2017 Ford Mustang V8-5.0L

CONVERTIBLE - ROOF SAGGING AT THE REAR GLASS

18-2036
06 February 2018

This bulletin supersedes 16-0104. Reason for update: Concern Carryover to New Model

Figure 2

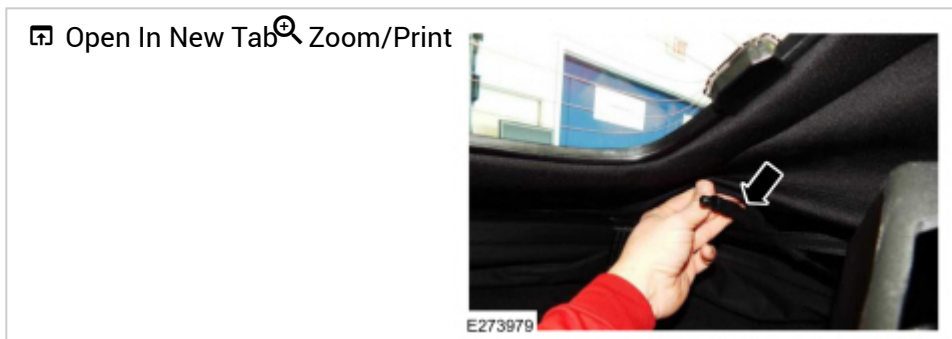
**4. Lift the headliner over the rear glass tension rods. (Figure 2)**

Figure 6

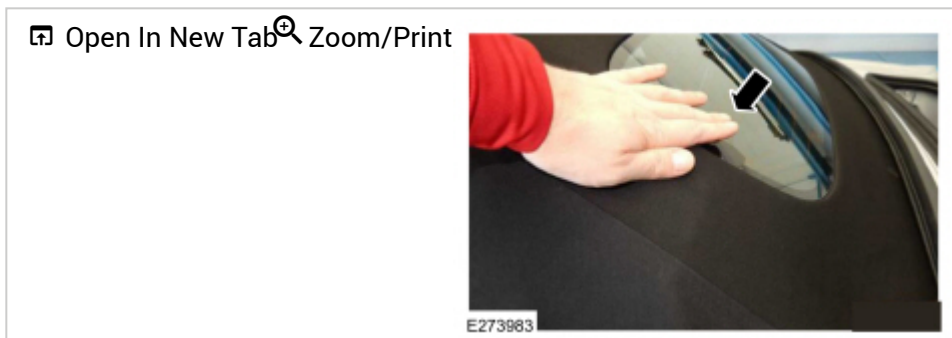
9. Slightly press on the convertible top as shown to verify the rear glass tension rod is connected to the rear glass frame. (Figure 6)
